**Design Review Board Case #2018-0013**  
**2425 Eisenhower Avenue – Block 6C Retail Pad Site**

Application	General Data	
<b>Project Name:</b> 2425 Eisenhower Avenue – Block 6C Retail Pad Site  <b>Location:</b> 2425 Eisenhower Avenue  <b>Applicant:</b> 2425 Eisenhower Acquisitions, LLC	<b>DRB Date:</b>	July 19, 2018
	<b>Site Area:</b>	.36 acres (15,849 sf)
	<b>Zone:</b>	CDD#2
	<b>Proposed Use:</b>	Residential, Retail, and Associated Parking
	<b>Gross Floor Area:</b>	7,791 sf
<b>Purpose of Application:</b> Initial concept review of a one-story retail building and site improvements proposed for retail and restaurant uses at 2425 Eisenhower Avenue adjacent to the existing Hoffman Town Center. This proposal includes 7,791 sf of retail uses.		
<b>Staff Reviewers:</b> Rob Kerns, AICP <a href="mailto:robert.kerns@alexandriava.gov">robert.kerns@alexandriava.gov</a> Thomas H. Canfield, AIA <a href="mailto:tom.canfield@alexandriava.gov">tom.canfield@alexandriava.gov</a> Nathan Imm, <a href="mailto:nathan.imm@alexandriava.gov">nathan.imm@alexandriava.gov</a> Bill Cook, AICP <a href="mailto:william.cook@alexandriava.gov">william.cook@alexandriava.gov</a>

2425 Eisenhower Acquisitions, LLC is

Figure 1: Roof, Entry, Glazing

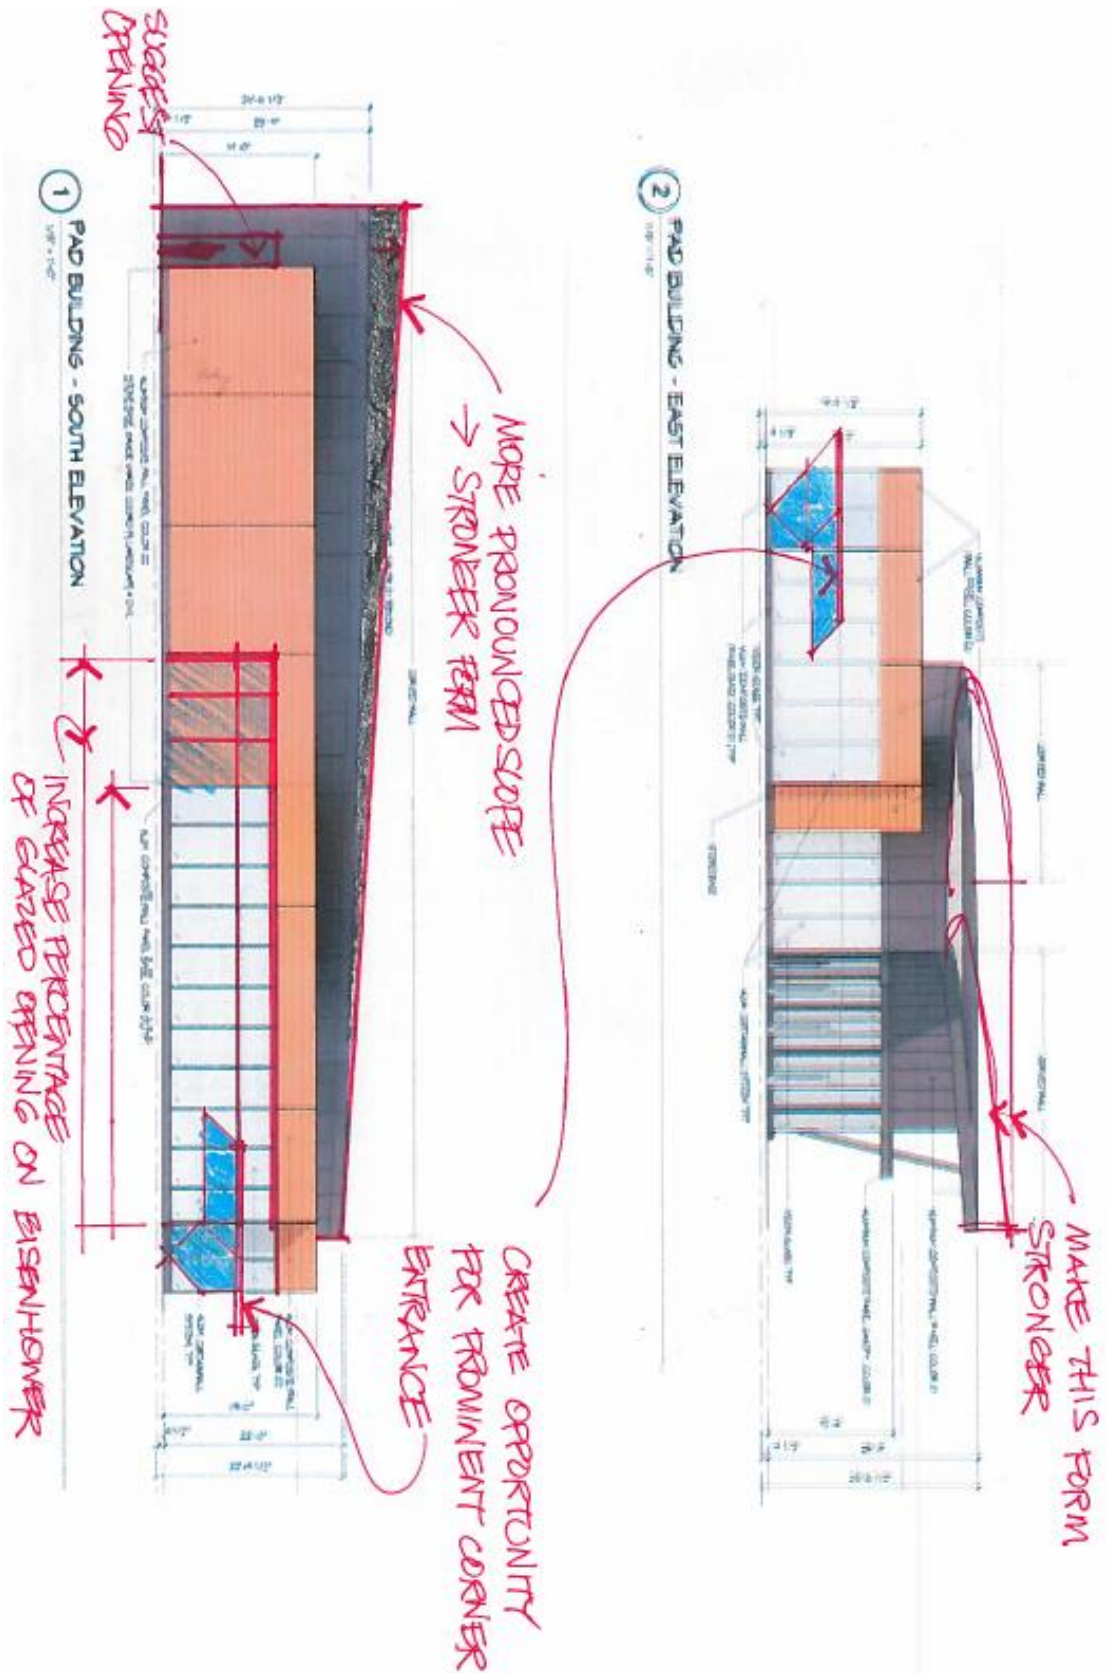
- Study the addition of a glass canopy and provision for direct entry at the prominent corner of Eisenhower & Swamp Fox to address future retail demand and pedestrian convenience. (Figures 1-3)
- The Design Guidelines call for main pedestrian building entries to be located along “A” street frontages. At present all storefront entries are located facing the Town Center circle. Provide an entry on additional sides or corners.

- Study increased height of the curved accent form for a more dramatic slope and stronger presence. (Figures 1-2)
- Study addition of beam or trellis elements to screen views of rooftop equipment from NSF Headquarters building. Consider a green roof treatment to enhance the roof view and contribute to storm water management. (Figure 2)
- Study addition of a vertical cutaway from grade to top of typical glazing to clarify formal relationship.
- Provide a green roof on the section outside of the sloped accent form.

- Increase glazed area westward along Eisenhower Avenue to break the impression of a 50/50 solid/glass split. (Figure 1). Further develop this façade to reflect its prominence along an "A" street.

Figure 3: Site

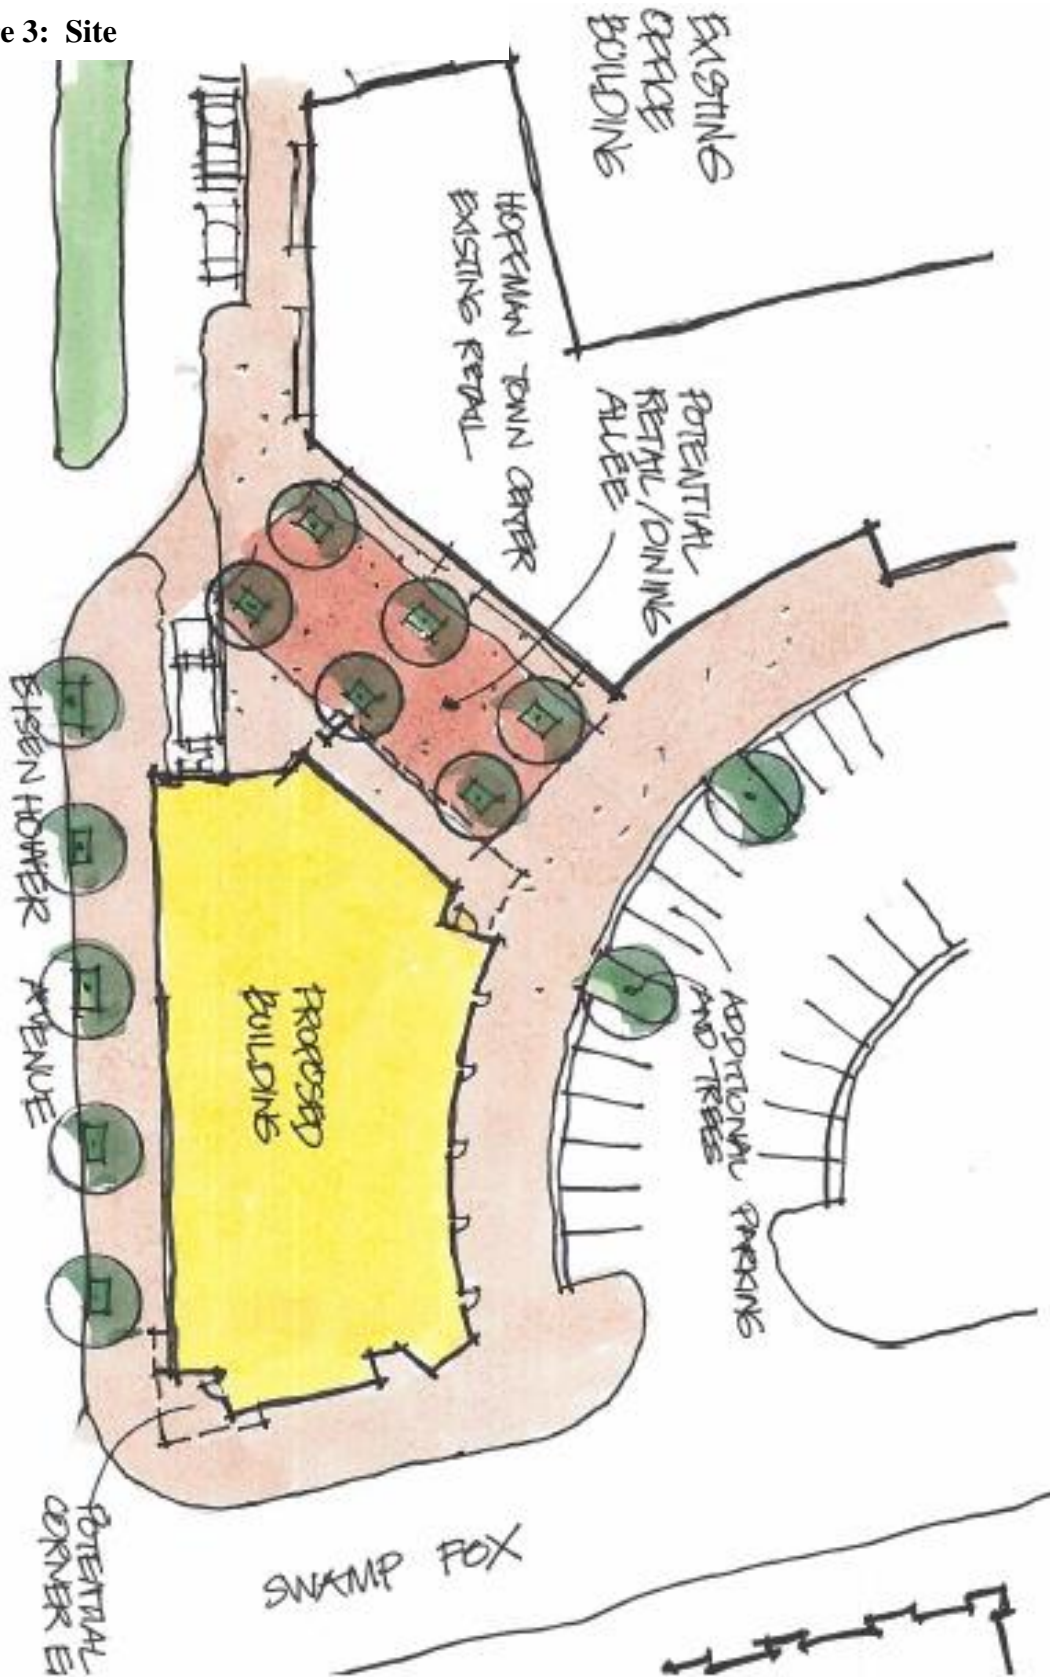
- The Eisenhower East Small Area Plan envisions the Hoffman Town Center as a pleasant pedestrian-oriented environment. As part of this proposal, explore utilizing the private street as an active public space which could encompass numerous potential uses. Features could include: additional parking spaces in the semicircle, creation of an expanded and tree-shaded outdoor plaza area for dining and seating between the proposed building and the existing

restaurants, reduction in potential vehicular/pedestrian conflicts, improved site integration with Block 6B office building entry and existing Starbucks. (Figure 3).
